Permit Application Technical Review: Permit Application: Structure PC2239 – Wind Turbine

We have completed a review of the structure reference above. This structure was previously studied under FAA's airspace review as study 2023-WTW-15845-OE. It is also noteworthy that this structure is under current study under airspace review as study 2024-WTW-1119-OE; which has not been determined at this time. This review is organized around the following sections of the ordinance:

PEYTON CREEK II WIND FARM
MATAGORDA COUNTY, TEXAS
ROADS RD PC2-183, RD PC2-185 & RD PC2-238

Aeronautical Study No.
 2023-WTW-15845-OE

WTG Foundation PC2-239

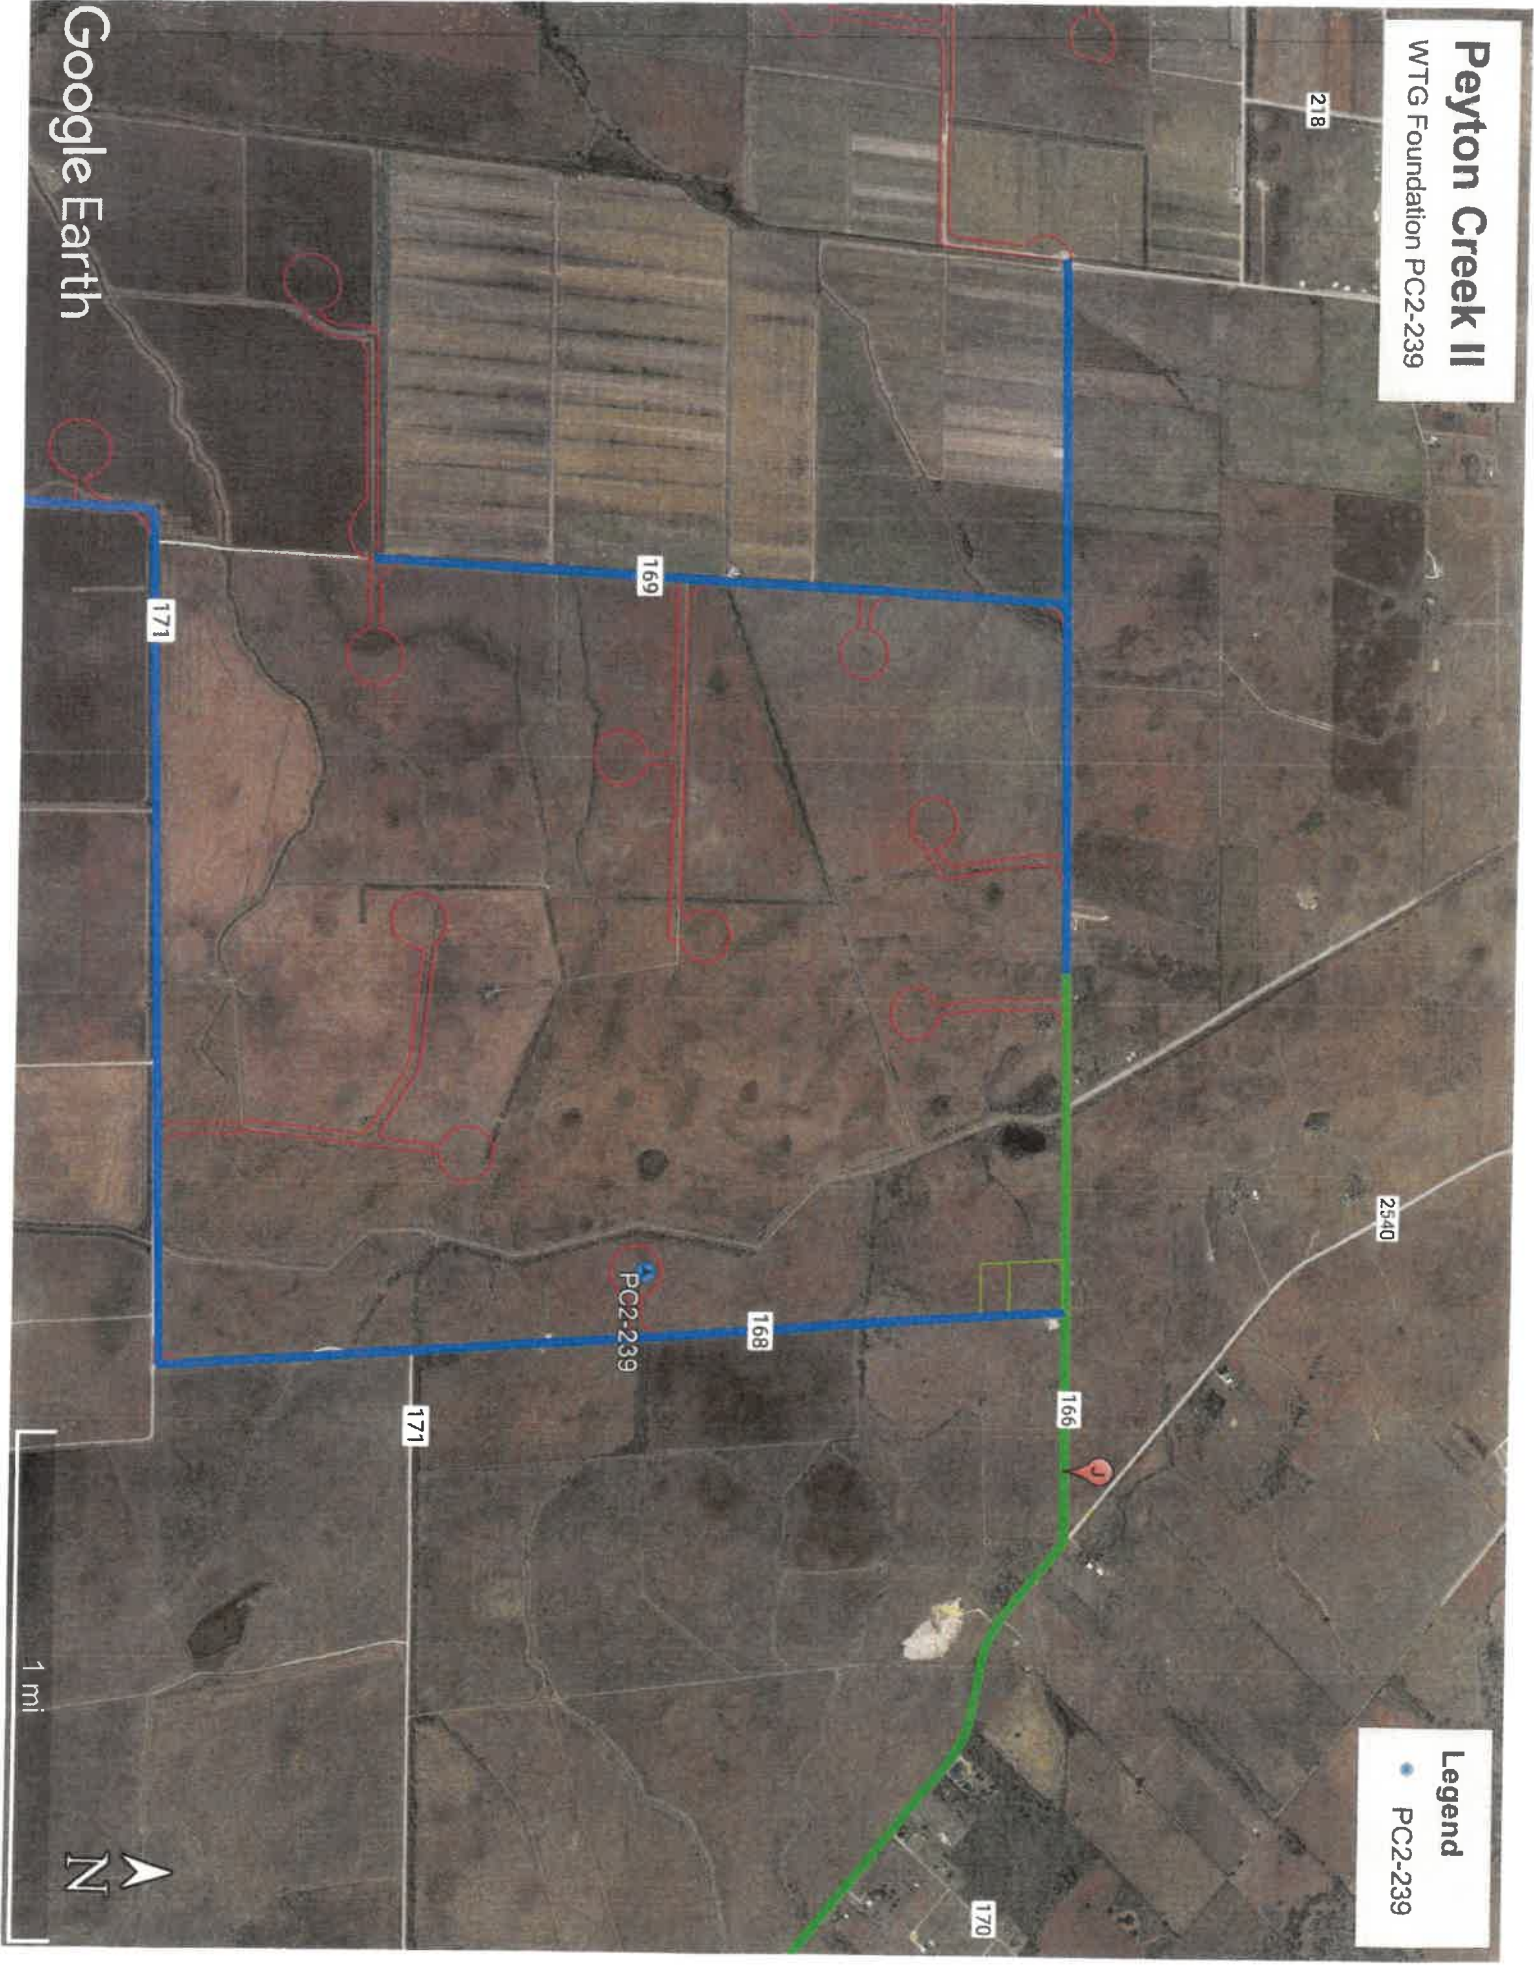
Reasons: This section does not permit use of land or water in the entirety of Matagorda County that might impair visibility in the vicinity of the airport, or otherwise in any way endanger or interfere with the landing, taking off, or maneuvering of aircraft intending to use the airport. This proposed item will affect landing and taking off from the airport in multiple ways:

1. This proposed structure is located 3.57 nm from the end of Runway 31, its departure end. This structure is within the "Diverse Departure Assessment Area" as defined under FAA Order 8260.3D and may require an Obstacle Departure Procedure. For southbound departures from the runway toward the proposed structure, the climb gradient needed to provide proper clearance over the structure will exceed the standard climb gradient; this has been noted in the airspace determination letter of December 20, 2023. Such a requirement interferes with operating out of the airport compared to the operating requirements today. As noted above, this structure is also under a current airspace study of which it is unknown as to the FAA's determination on it.

Based on the information provided above, we find this proposed structure to be contradictory to the zoning ordinance and hereby do not recommend approval of this structure.
